Application No. 09/702,218
Amendment dated November 13, 2003
Reply to Office Action of July 21, 2003

REMARKS/ARGUMENTS

FIG. 6

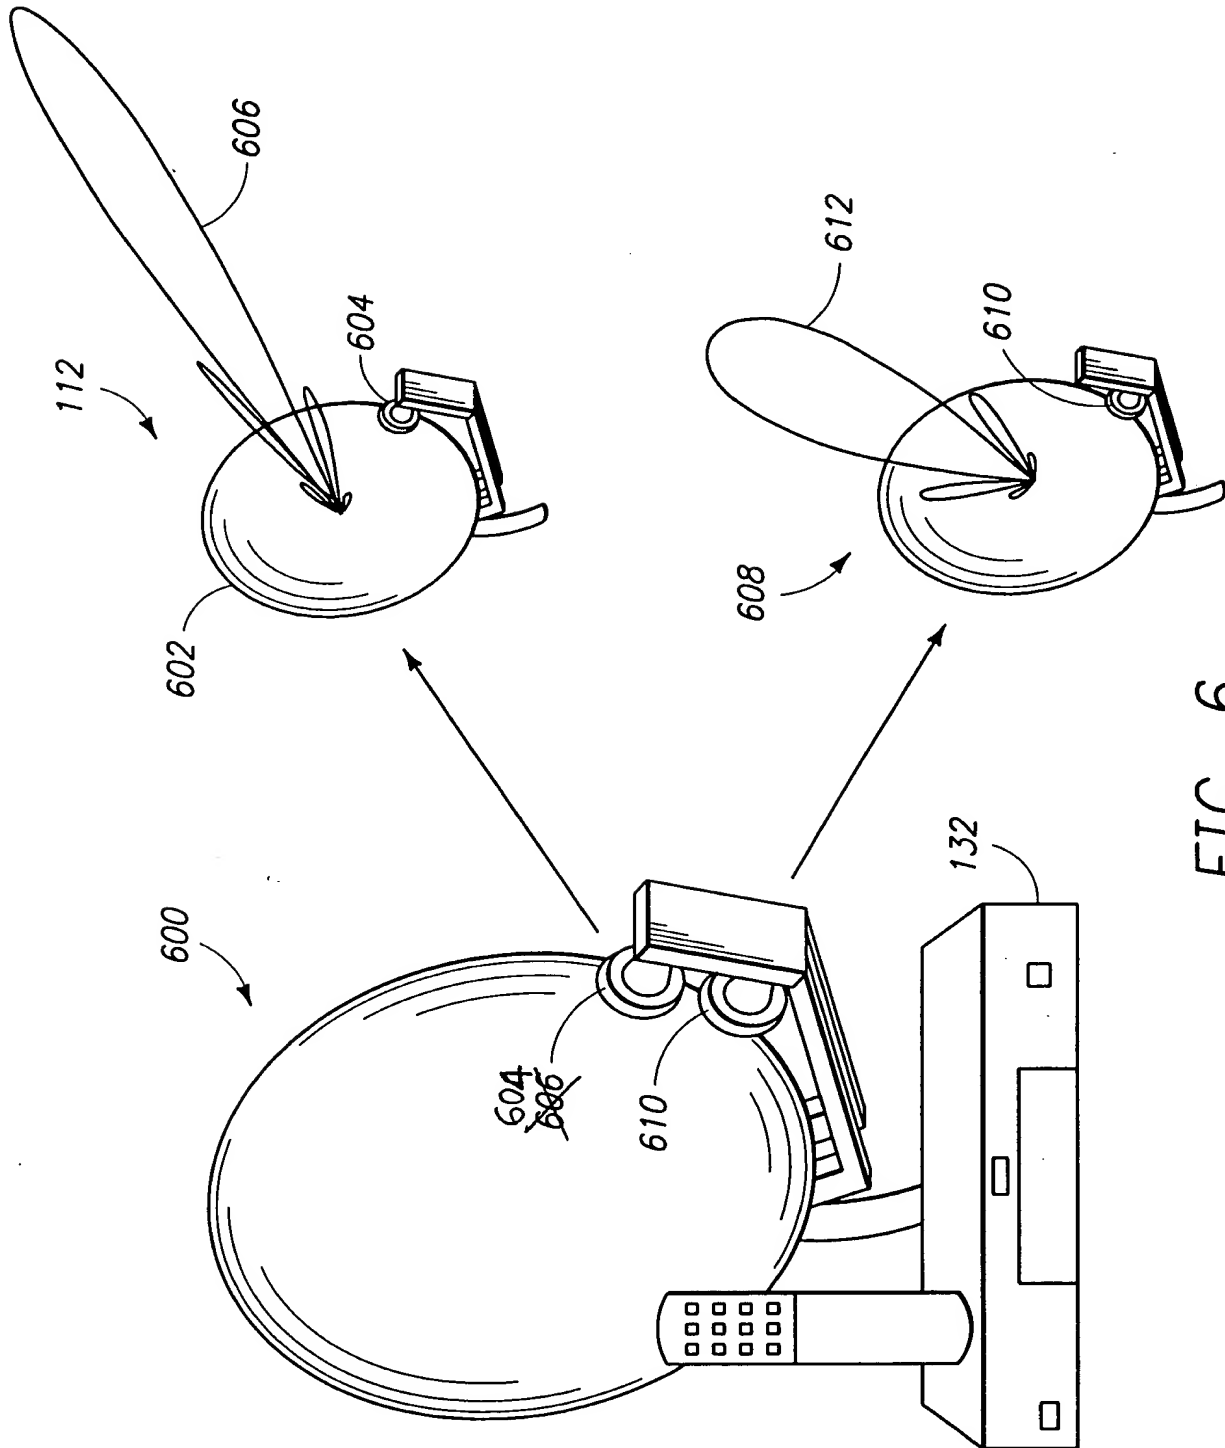
In the drawings, Figs. 6 and 7A are being corrected. In Fig. 6, the reference numeral "606" for the first LNB has been corrected to "604". The same change has also been made in Fig. 7A. For support, see for example, page 9, line 30 and page 10, lines 9 and 10. In Fig. 6, the baseline antenna sensitivity pattern is already (correctly) labeled as "606".
